**JOINT REGIONAL PLANNING PANEL**

**SUPPLEMENTARY REPORT**

<b>JRPP No.</b>	JRPP Reference Number 2014STH004
<b>DA Number</b>	263-2013
<b>Local Government Area</b>	Queanbeyan City Council
<b>Proposed Development</b>	Staged development for the conceptual development of South Tralee urban release area involving five stages, the road hierarchy and master plan for future subdivision for 1,348 dwellings (approx), commercial and community facilities, open space and recreation areas, and associated servicing.
<b>Street Address</b>	360A and 360B Lanyon Road, Tralee NSW 2620, 508 Lanyon Drive, Jerrabomberra NSW 2619 and part of Territory Parade and Boundary Road
<b>Applicant/Owner</b>	Canberra Estates Consortium No. 4 / Village Building Company, John Bernard Morrison, Therese Mary Hansen, and Queanbeyan City Council
<b>Number of Submissions</b>	Amended Proposal – Nil  Original Proposal - Four submissions made during the period of public notification and one late submission from the ACT Government

## Supplementary Assessment Report and Recommendation

Figures 1 and 2 below show the original and amended road layout within Stage 2.

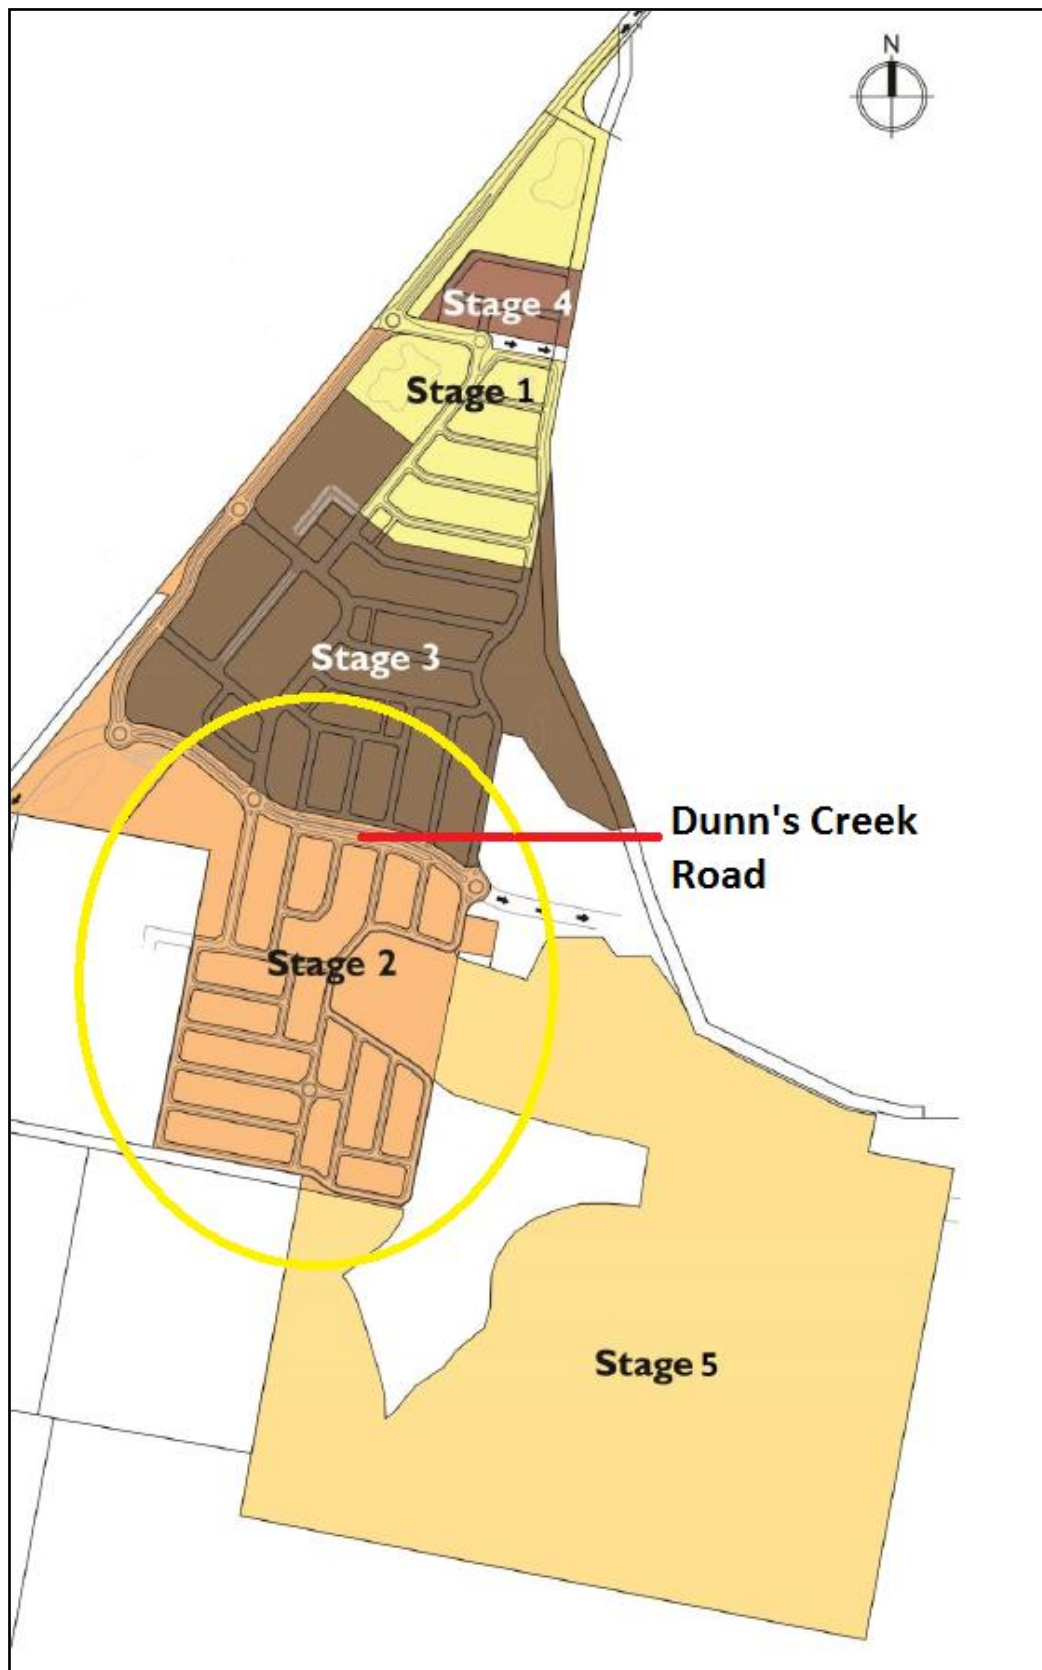
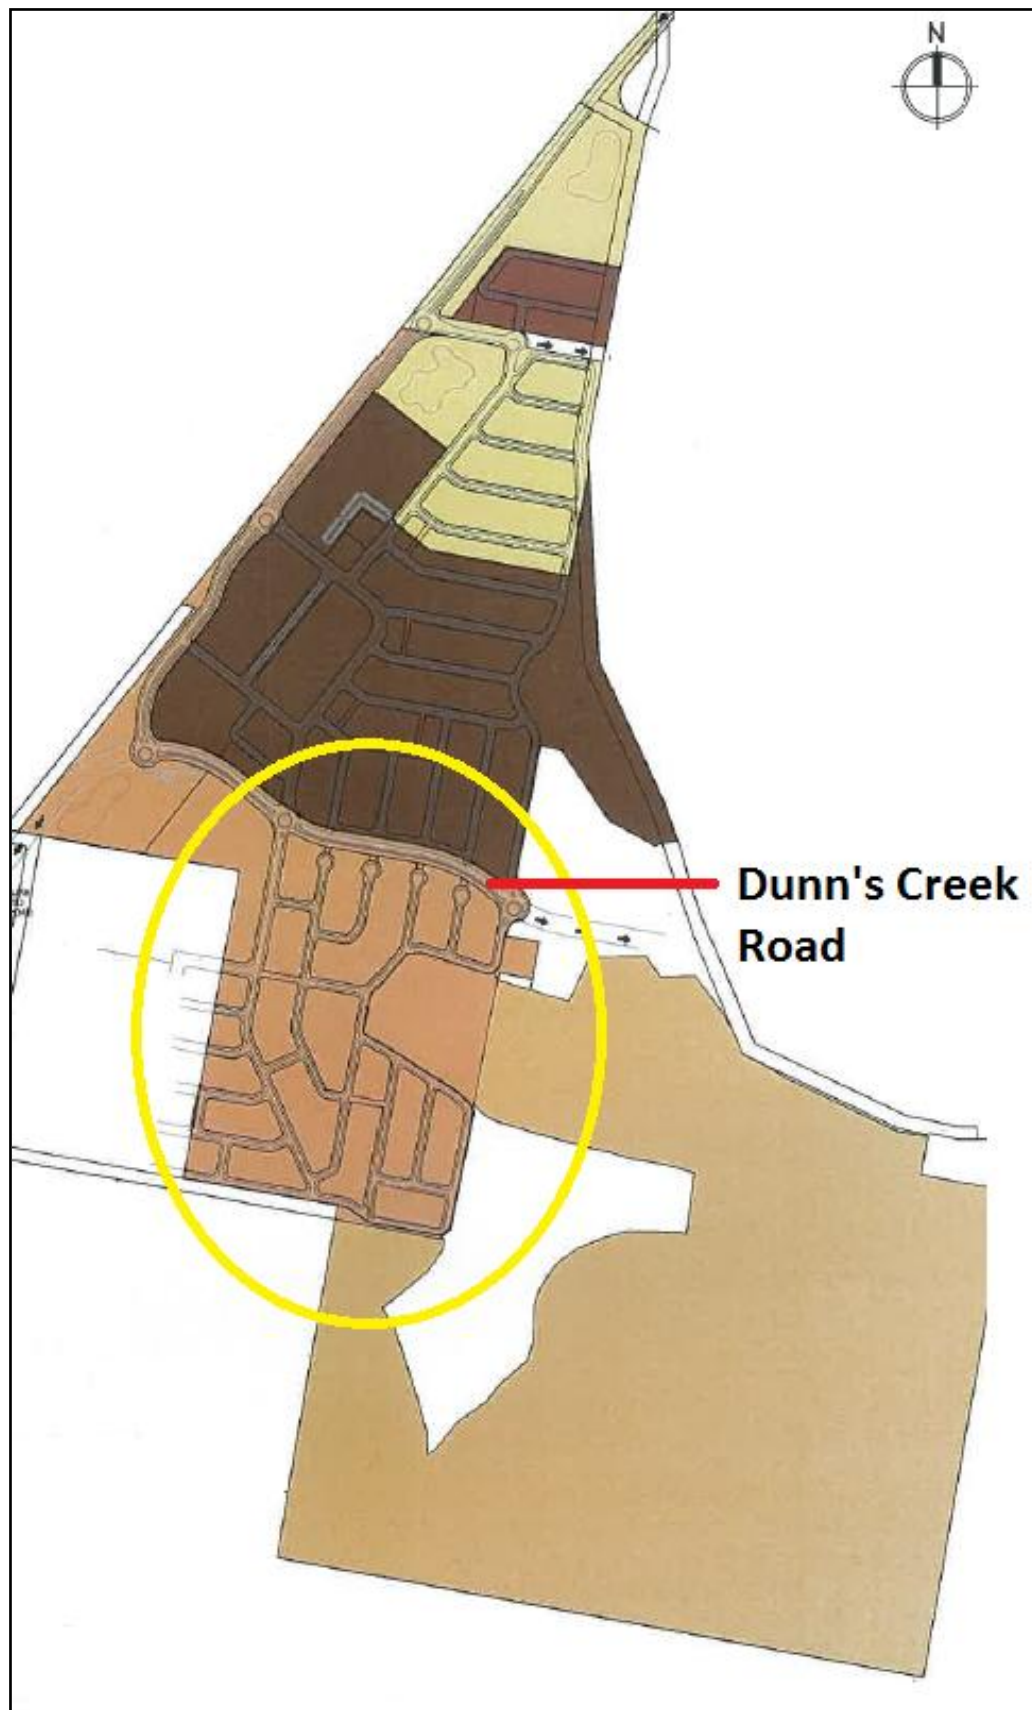
As part of the amended application the following changes have been made to the part of the concept development of South Tralee identified as being within Stage 2 (South of Dunn's Creek Road) on the submitted Staging Plan.

- b. Streets in the south-west corner of Stage 2 have been reconfigured to match the proposed new alignment of Road 40;
  - c. Roads 27 and 36-39 provide for connection to the land to the west of Stage 2 identified for future residential development; and

*Figure 3 - Amended Plan*

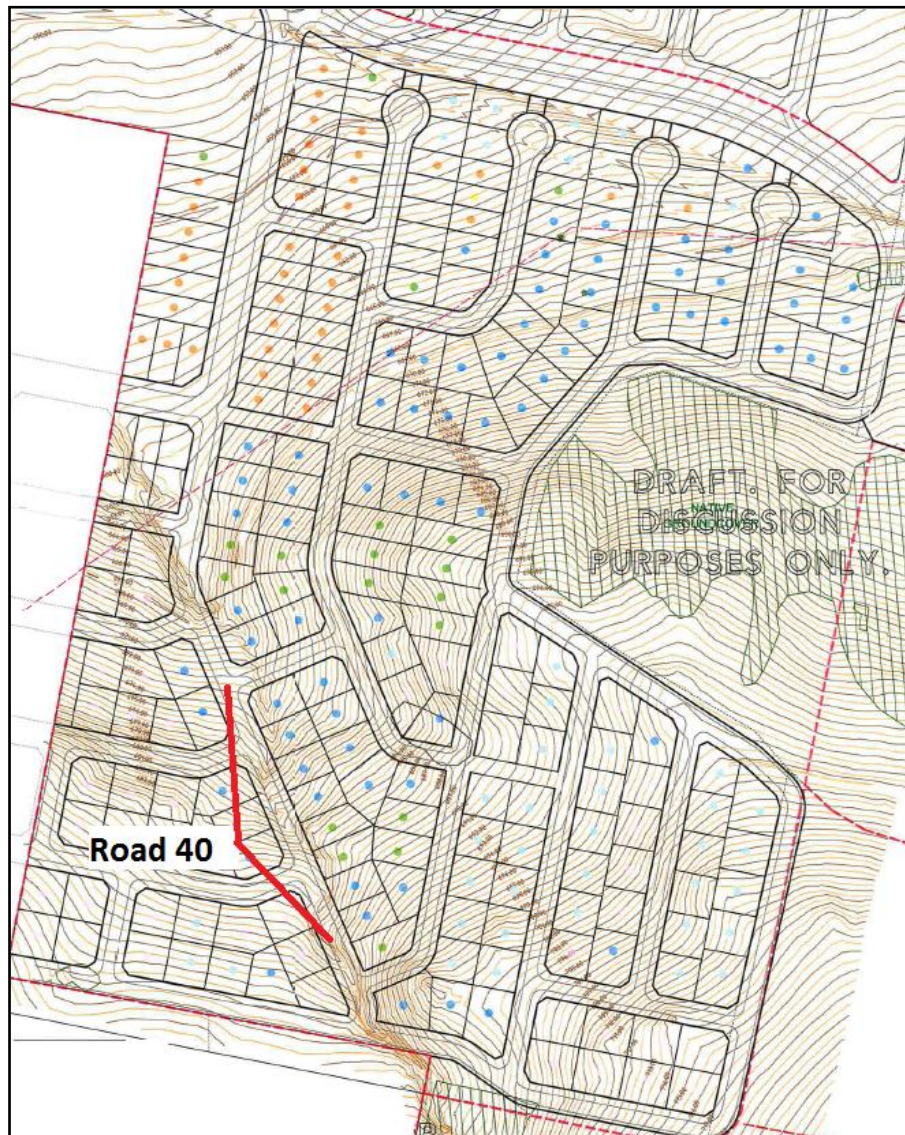
The amended proposal has reduced the amount of earthworks required adjacent to the incised gully and better reflects the drainage function of the land by allowing stormwater to flow along roads aligned with the gully, specifically new Road 40 – refer to Figure 3 below.

*The revised design in this area [gully] is still a totally engineered product, however, the revised layout does produce a road pattern that limits the extent of fill by having Road 40 aligned with the creek line with the subdivision areas falling towards the road. Residential lots are thereby positioned outside the fill area. The Stage 2 design plans will need to provide detail of the proposed means of stabilising and filling the creek line.*

**Prior to the determination of any Development Application for Stage 2 of the development of South Tralee as identified on the approved Staging Plan, details about the proposed means of stabilising and filling the creek line in the proximity of Road 40 must be submitted to Queanbeyan City Council for assessment.**

**Figure 4 – Alternative Design**

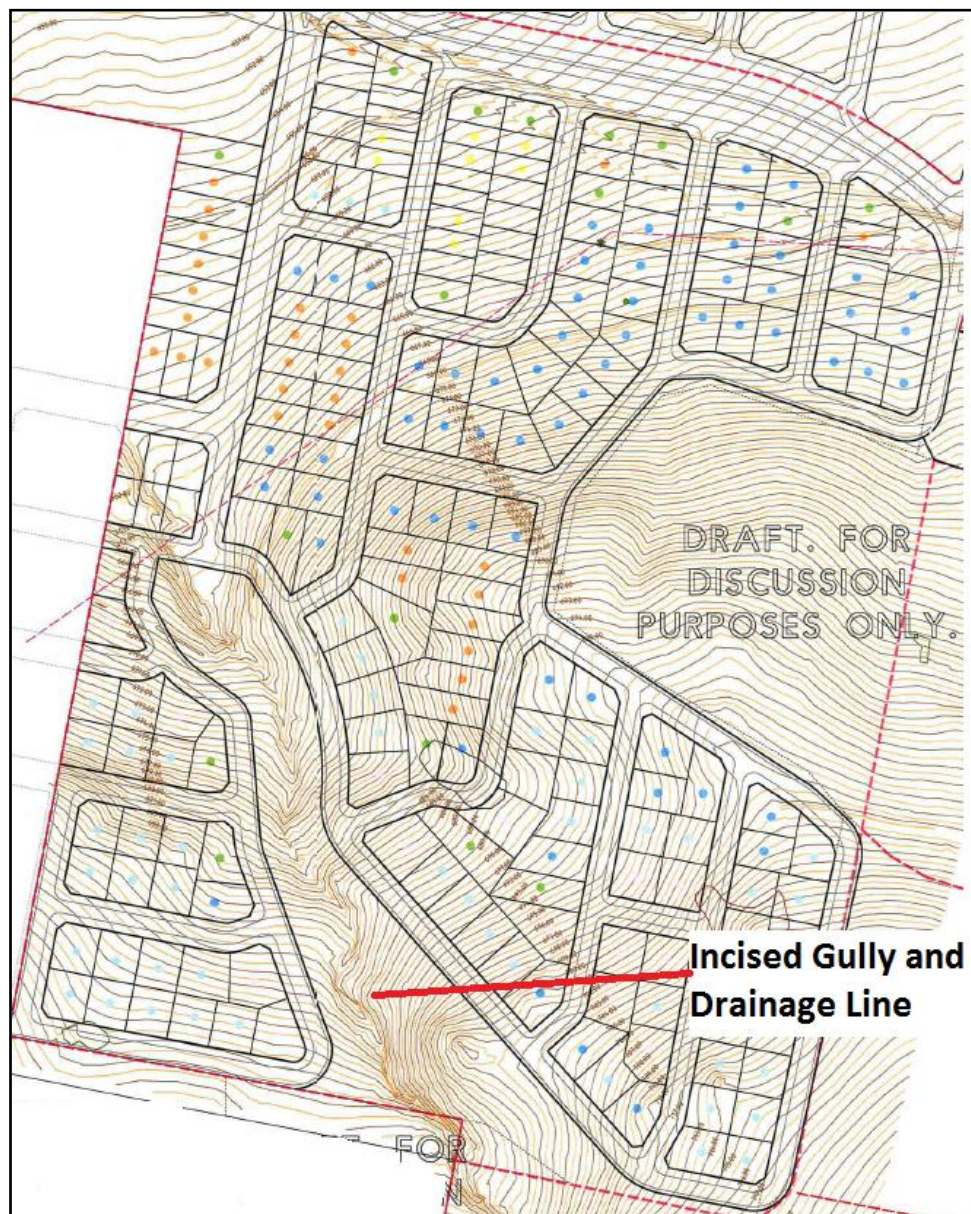
The option of completely excising the gully from the concept subdivision by creating road boundaries along either side of it has been considered by both the applicant and Council. The applicant argued against pursuing this option due to it resulting in the loss of 39 future residential allotments making the development financially unviable, as well as the issue of ongoing costs of long term maintenance and public safety of leaving the steeply incised gully in-situ. A map of this option is provided in Figure 4 below.

The advantages of the above option are that the existing topography and drainage function of the gully is largely maintained, a clump of native vegetation and trees is maintained, and the amount of earthworks required is substantially reduced. However, it does remove a substantial amount of residential zoned land from being developed for future residential allotments and still results in an increase to the amount of lots which will have a non-preferred solar orientation.

warrant the pursuit of this option. The option outlined in the amended application is considered to be a sensible response to Council's concerns regarding the original proposal which can be supported.
